IN THE ABSTRACT:

IN THE DRAWINGS:

REMARKS

FIG. 2

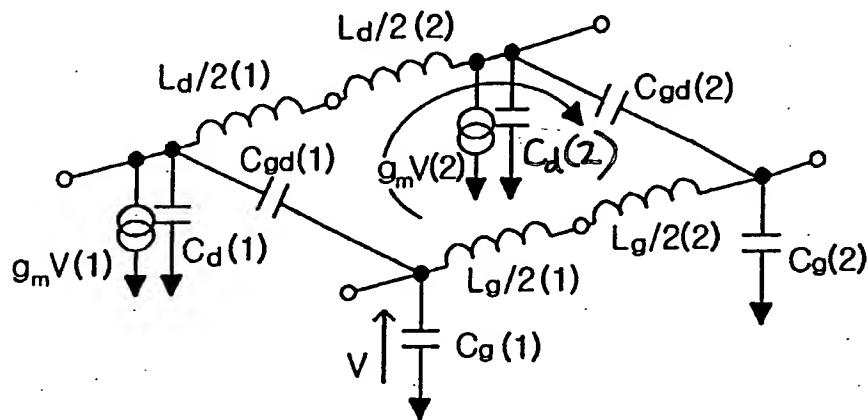
Please amend Fig. 2 to include reference $C_d(2)$ for the capacitor next to $g_m V(2)$, as marked in red on the copy of Fig. 2 attached hereto for approval by the Examiner.

This objection has been addressed by adding Fig. 9, as indicated above, and by amending the page 2, lines 8 and 23 of the specification to refer to Cgd rather than Cds. In addition, the un-numbered capacitor in Fig. 2 has been labeled as Cd(2), consistent with the labeling of capacitor Cd(1).

FIG. 8

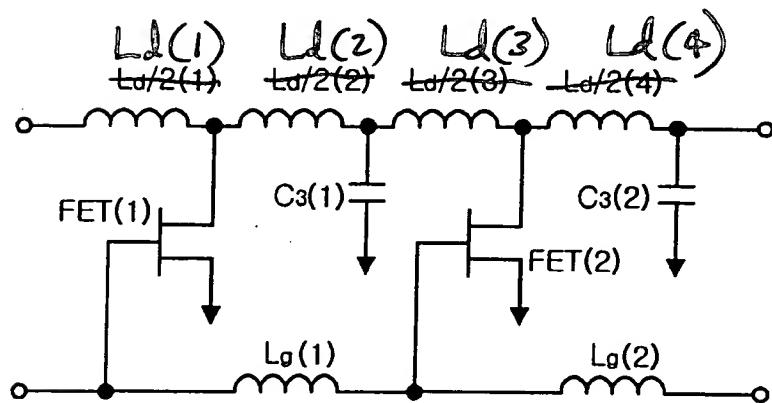
Please amend Fig. 8 by changing reference "Ld/2" to -L- for the four indicators at the top of the circuit, as marked in red on the copy of Fig. 8, attached hereto by the Examiner.

the location of the additional capacitance can be anywhere in the drain line, . . . , it is most effective in optimizing the gain-bandwidth product of traveling-wave amplifier having II-type drain transmission line structure when the x value is 0.5."). Fig. 8 has also been amended for consistency, as has the paragraphs bridging pages 10 and 11 of the original specification.

In FIG. 8, the drain terminal of FET(1) is connected between drain line $[L_d/2(1)] L_d(1)$ and $[L_d/2(2)] L_d(2)$, and the additional capacitance $C_3(1)$ is connected between drain line $[L_d/2(2)] L_d(2)$ and $[L_d/2(3)] L_d(3)$.

Also, the drain terminal of FET(2) is connected between drain line $[L_d/2(3)] L_d(3)$ and $[L_d/2(4)] L_d(4)$, and the additional capacitance $C_3(2)$ is connected to the drain line $[L_d/2(4)] L_d(4)$.

Fig. 9

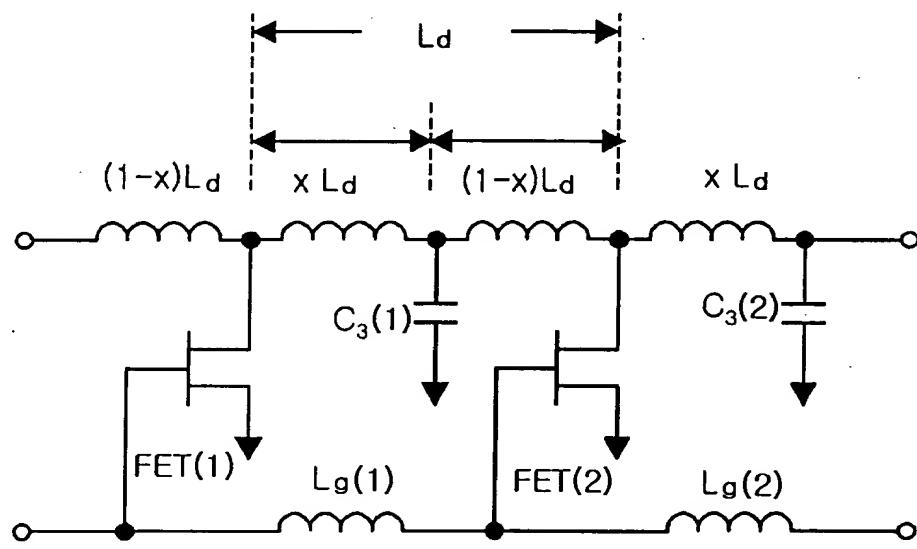
Please add new Fig. 9, attached hereto for approval by the Examiner.

- (i) Adding Fig. 9 to correspond to the description of Fig. 9 in lines 23-25 on page 9, and beginning in line 23 on page 10, as suggested in item (1) of the objections, (new Fig. 9 being identical to the corresponding Fig. 9 of the priority application); and
- (ii) Correcting the typographical error in line 17 on page 11.

In addition, the "0.5" language of claim 3 has been modified to point out that the preferred lengths of the drain lines is $-0.5L_d$, which is half the distance between the FETs, as shown in Fig. 9, and explained in lines 16-19 on page 11 of the original specification ("Although

As shown in FIG. 9, the total length of drain line between the drain terminals of the said FET(1) and FET(2) is represented as L_d , and the length of drain lines $L_d(1)$ and $L_d(3)$ is $(1-x)L_d$ and that of $L_d(2)$ and $L_d(4)$ is $(x)L_d$, respectively, where x is the number larger than 0 and smaller than 1 ($0 < x < 1$).

~~20~~ Although the location of the additional capacitance can be anywhere in the drain line (i.e., $0 < x < 1$ in Fig. 9), it is most effective in optimizing the gain-bandwidth product of traveling-wave amplifier having Π -type drain transmission line structure when the x value is 0.5.
